Informal document **GRSP-51-32**
(51st GRSP, 21 - 24 May 2012,
agenda item 13)

Helmet

Helmet Visor and Sunscreen

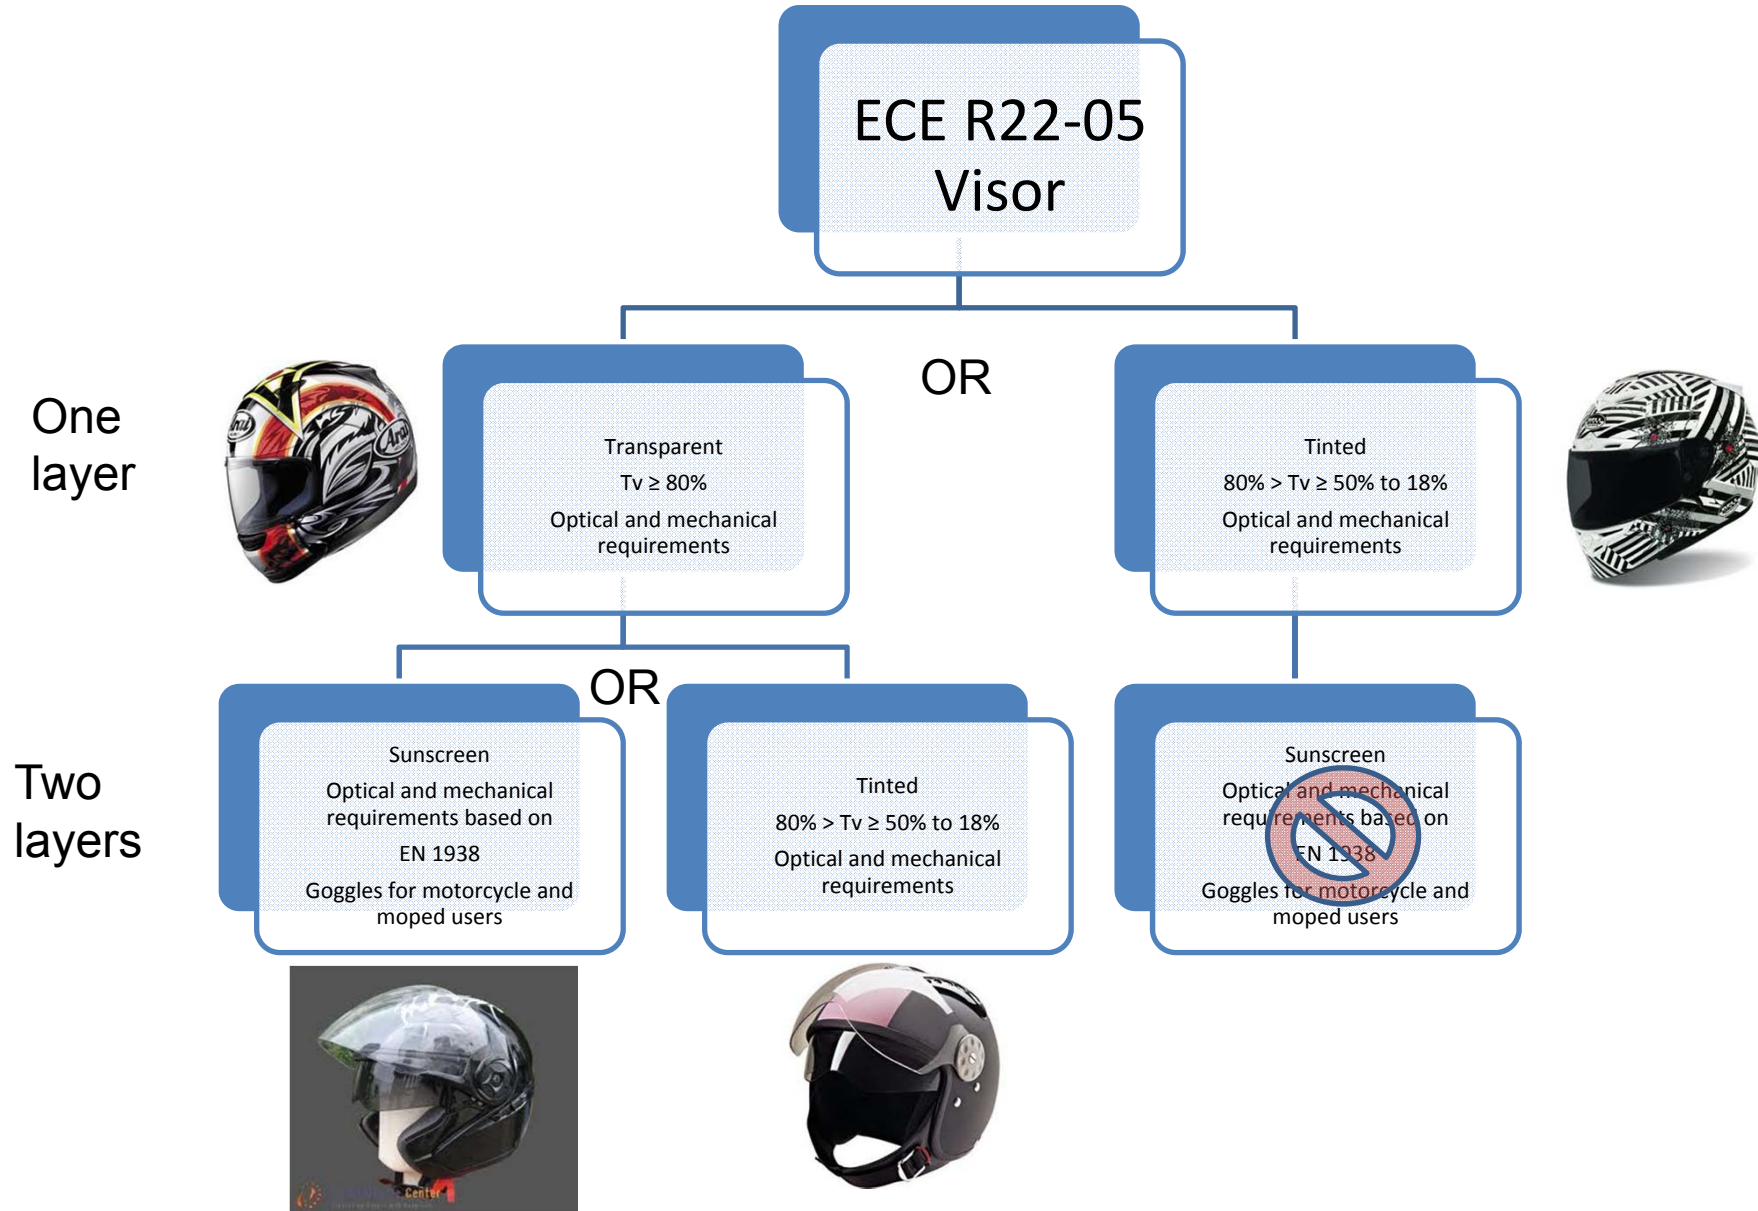
We find on the market some helmets equipped with integrated sunscreen (5). These sunscreens are not approved according to ECE R22-05, and modify the luminous transmittance. Moreover, helmet visors (3) which not met luminous transmittance criteria of ECE R22-05 could be found, as spare parts, on the market.

- 1- ECE R22-05 transparent visor $T_v \geq 80\%$
- 2- ECE R22-05 tinted visor $80\% > T_v \geq 50\%$
- 3- Visor supplied as spare parts with helmet
(but without type approval)

- 4- ECE R22-05 visor
- 5- Sunscreen integrated in Helmet, without type approval

- We will propose for next meeting a document to amend current ECE R22.05 in order to take into account this innovation.
- This document will be based on the following principles :
 - Authorises in ECE R22-05 tinted visor with lower light transmission
 - Creates the sunscreen definition in ECE R22-05
